REPORT AMENDED BY STAFF 5-9-89  
**CITY PLANNING COMMISSION**

P89-130

- A. Negative Declaration
- B. Special Permit to develop a 162,235+ sq. ft. office building with 630 parking spaces in the Heavy Commercial-Review (C-4-R) and Heavy Industrial (M-2) zones
- C. Plan Review for a 162,235+ sq. ft. office building in the C-4-R zone

**PROPOSAL:** The applicant is requesting the necessary entitlements to construct a 162,235+ square foot office building in the C-4-R and M-2 zones.

EXHIBIT B

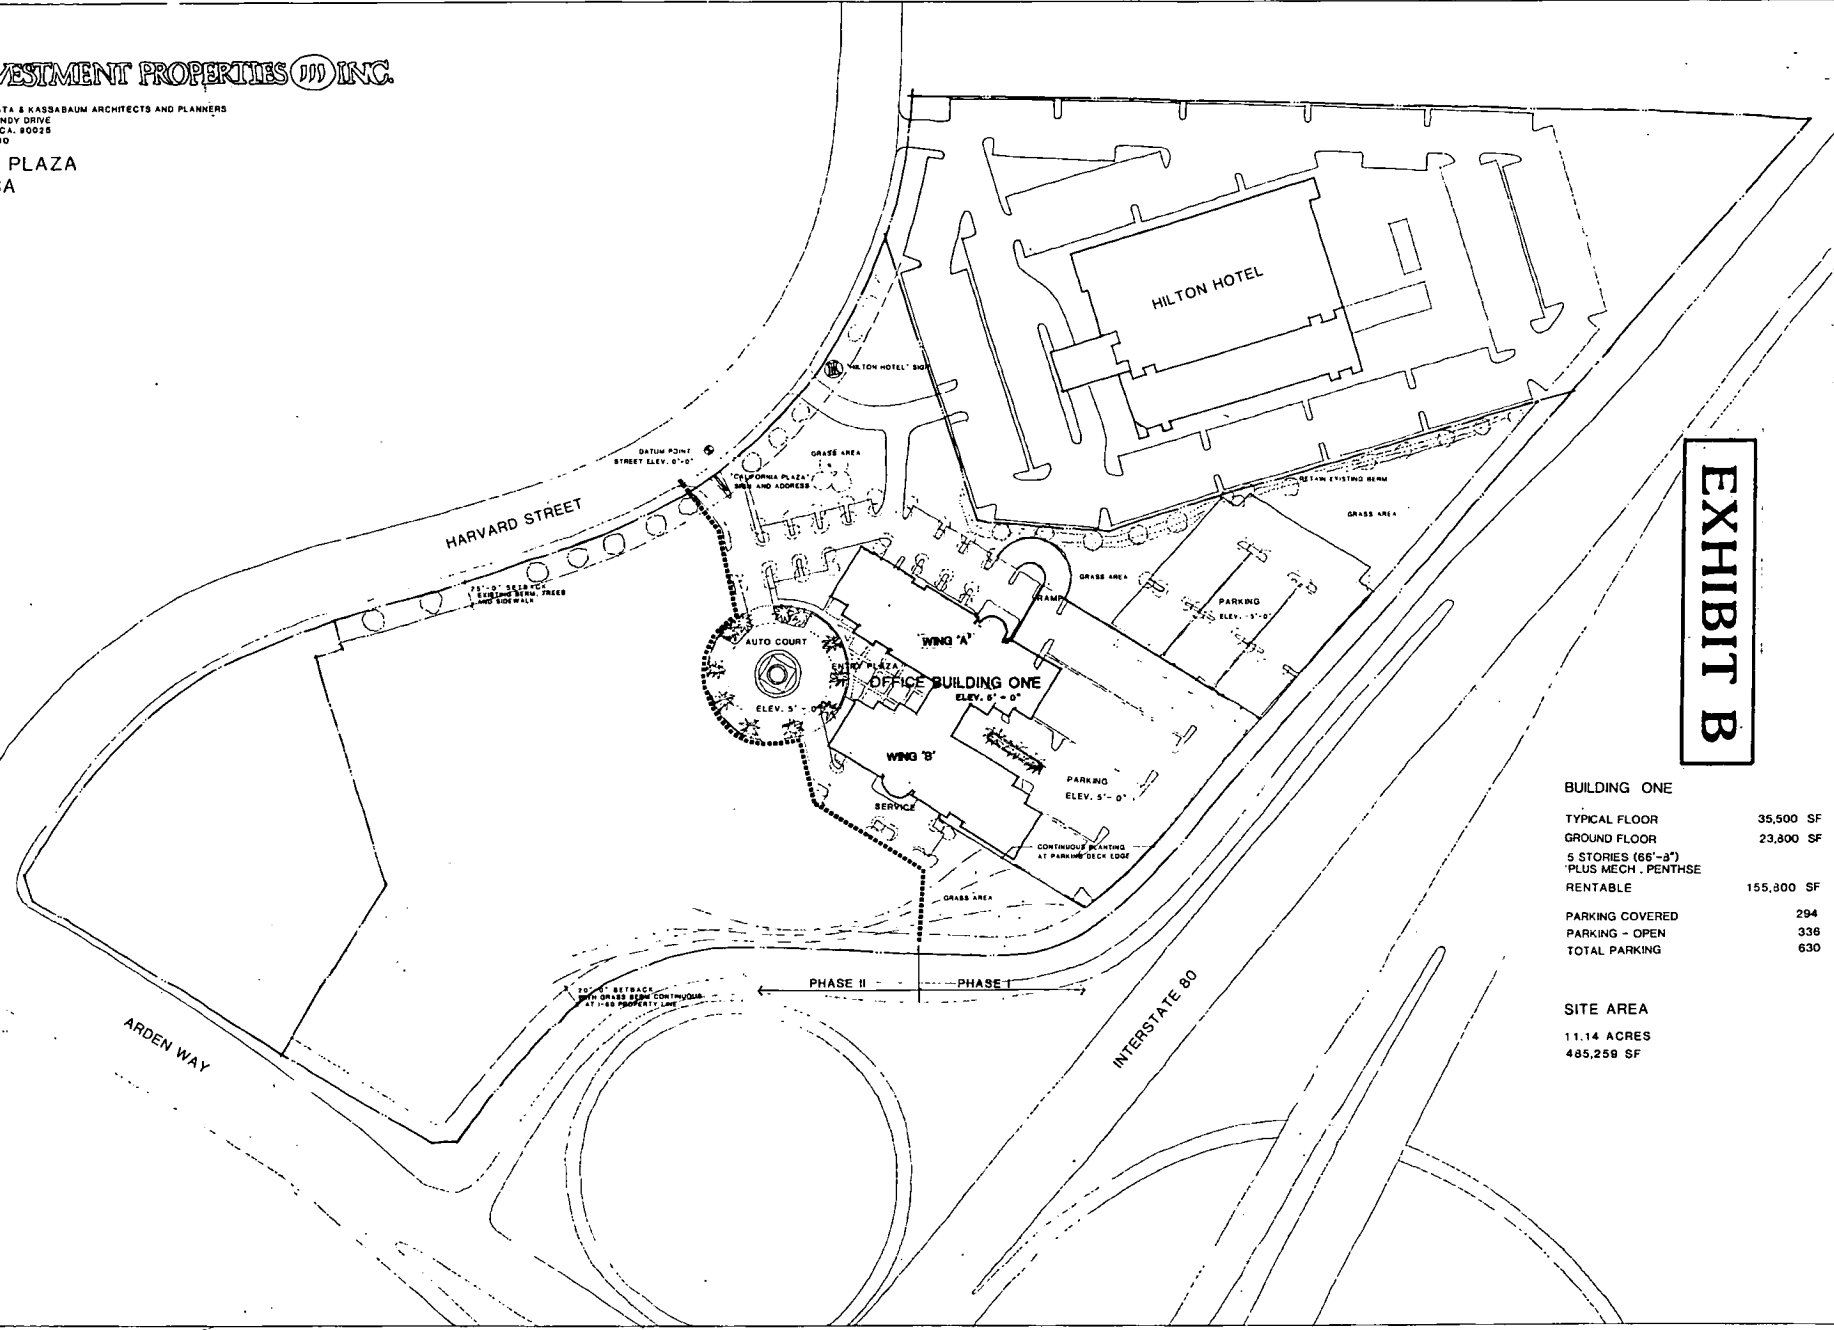
The east side of Harvard Street north of Arden Way to the end of the Hilton Hotel site is presently improved with sidewalk, curb and gutter. A 25 foot wide berm landscaped with trees and grass is located adjacent to the public right-of-way. The applicant intends for this minimum 25 foot setback to remain. Along the east property line adjacent to the freeway right-of-way a minimum 20 foot wide landscaped setback is indicated on the applicant's site plan. This will be compatible with the minimum landscape setback found on the Hilton Hotel site to the north. The applicant should provide a detailed landscape plan for Planning staff review and approval prior to issuance of building permits. Staff is especially interested in: the addition of landscaping on top of the parking deck; the proposed planting material at the parking deck edge and at the edge of the visitor parking; landscaping details at the auto court and entry court; and the location and type of existing and proposed trees and shrubs. The applicant will be required to meet the City's shading ordinance requirements.

The site plan and floor plans for the building indicate an entry court into the building. The applicant has indicated that proposed hardscape materials include smooth concrete and sandblasted concrete. Staff recommends that a brick paving material be included as part of the hardscape treatment. Planning staff also recommends that the applicant explore carrying the decorative treatment used at the entry court onto the top parking deck level.

A trash storage room has been indicated on the submitted floor plan. If any other trash areas are proposed the revised site plan should indicate these trash

The site plan indicates 630 parking spaces for the proposed office building. This number of spaces exceeds the minimum requirement of one space per 400 gross square feet (406 spaces). Planning staff recommends that, if it is necessary to reduce the number of parking spaces for the project, the applicant maintain a minimum parking ratio of one space per 300 gross square feet (541 spaces) which is also the parking requirement of the adjacent Capitol West Office Park PUD. Bicycle parking per Zoning Ordinance is also required.

1. All driveways shall be parallel to the street. Entry driveway divider shall be set in 20 feet from property line.
2. Provide plans showing parking ramp elevations and stall specifications.
3. Southern driveway shown for Phase II should be 30 feet in width and align with parking aisle.

- 1. A landscape, shading and irrigation plan shall be submitted and subject to Planning Director review and approval prior to issuance of building permits. The landscape plan shall detail the following:
  - a. minimum 25 foot landscape setback along Harvard Street as indicated on submitted site plan;
  - b. minimum 20 foot landscape setback adjacent to the freeway right-of-way as indicated on the submitted site plan;
  - c. addition of landscaping on top of the parking structure;
  - d. proposed planting material at the parking deck edge and at the edge of the visitor parking;
  - e. landscaping details at the auto court and entry court; and

- f. the location and type of existing and proposed trees and shrubs.
2. Final plans and elevations for the 162,235+ square foot office building, parking structure and entry court area shall be submitted for Planning Director review and approval prior to issuance of building permits. Revised plans shall indicate a decorative hardscape treatment including the use of brick, a decorative motif incorporated into the precast concrete panels of the building, and a screening treatment between the first and second levels of the parking structure where appropriate.

**EXHIBIT C**  
 Phase I & II

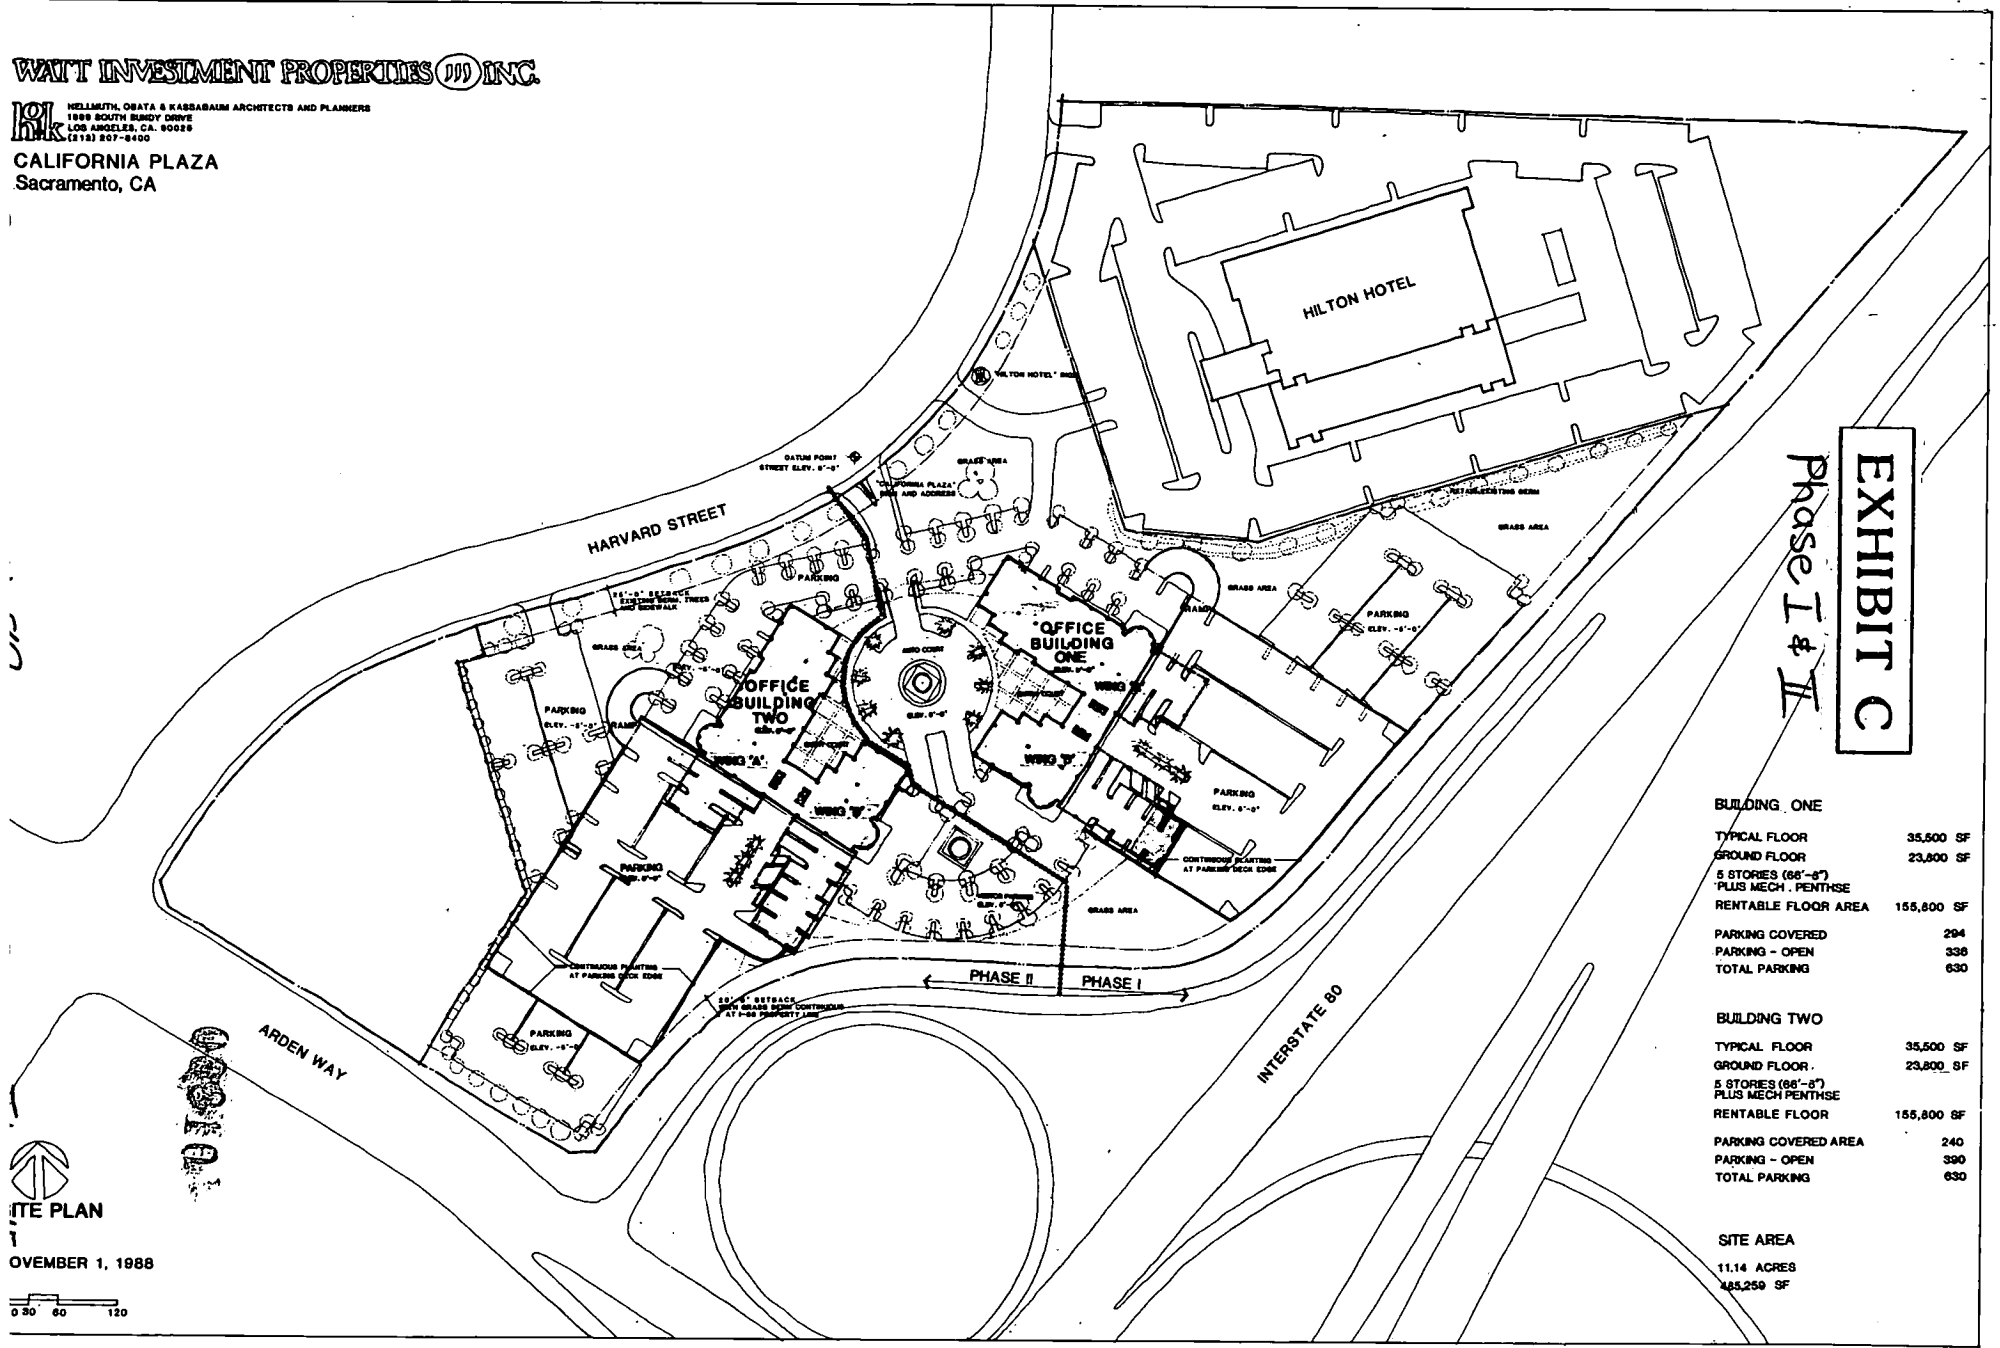
The applicant proposes to construct a 162,235+ square foot, 72+ foot high office building on the northern 6.13+ acres of the 11.14+ acre vacant parcel (Exhibits B-G). The project would include 630 parking spaces, a portion which would be below grade. As the proposed office is located in the C-4 and M-2 zones a special permit to develop a project which is 100% office use is required. A development plan review for a project in the C-4-R zone is also required. The proposed office building would be Phase I of a two phase office project (Exhibit C), however the applicant is requesting approval of Phase I only at this time.

EXHIBIT E

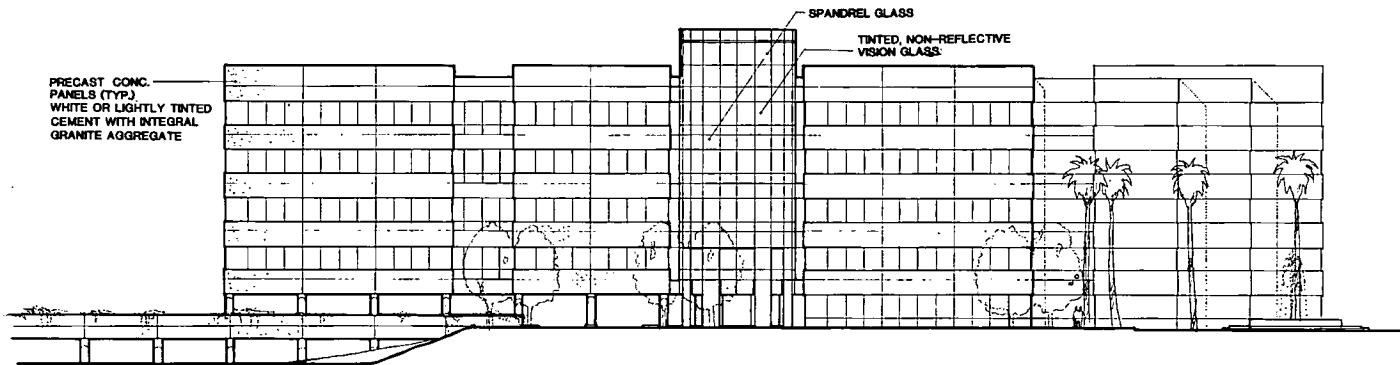
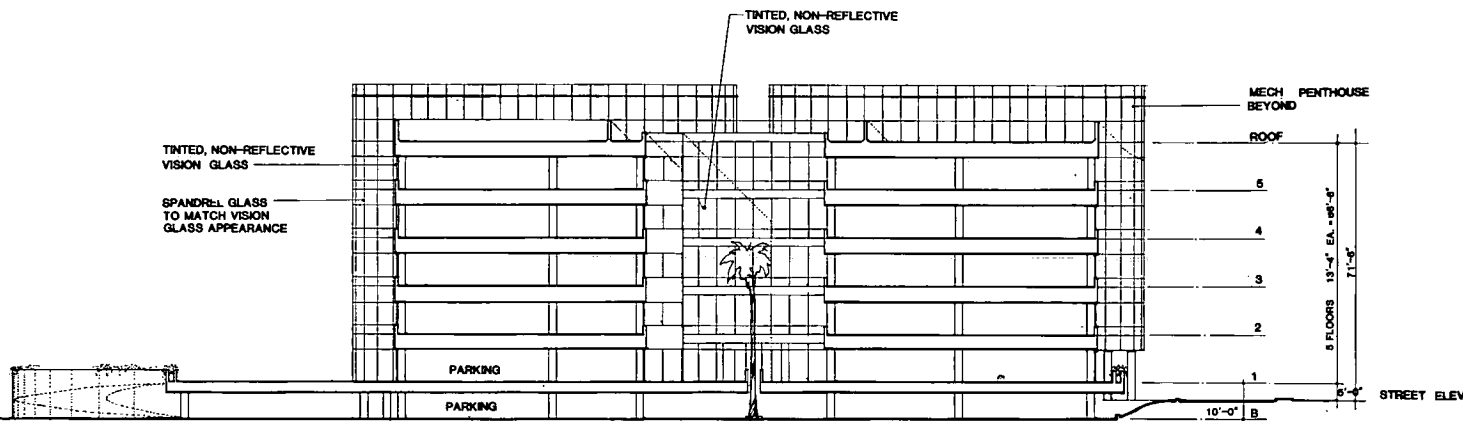
The proposed 162,235+ square foot office building consists of two, five-story wings connected by a five-story glass atrium. The mechanical equipment on top of the building will be shielded by a spandrel glass screen surrounding the top of the roof. Proposed height is 71'8" to the top of the roof and 87'8" to the

top of the building (mechanical equipment screen) measured from the Harvard Street grade. A level of parking will be constructed five feet below grade. Proposed building materials are pre-cast concrete panels with granite, and tinted glass. Proposed building colors range from white pre-cast concrete, grey tinted glass and blue metal mullions to a sand precast concrete, green tinted glass and teal mullions. A lighter tinted glass would be used in the atrium area with a darker tint on the building wings.

Planning staff finds the proposed building design to be interesting and compatible with the adjacent office buildings and Hilton Hotel. The building height is within the limits of the C-4 and M-2 zones (Maximum height 75 feet to plate line, 90 feet to top of mechanical equipment penthouse) and is similar to the surrounding buildings. The proposed building should have a decorative motif incorporated into the pre-cast concrete panels, such as the use of reveal lines. Planning staff prefers the sand pre-cast concrete and green tinted glass material samples presented by the applicant rather than the white/grey combination as the white building appears too stark. Planning staff recommends that the final architectural detailing for the project be reviewed and approved at staff level prior to issuance of building permits.

The applicant did not submit elevations for the proposed parking structure. These elevations should also be submitted for Planning staff review and approval. Planning staff recommends that some sort of screening element, such as a trellis or landscaping be indicated between the first and second levels where appropriate.
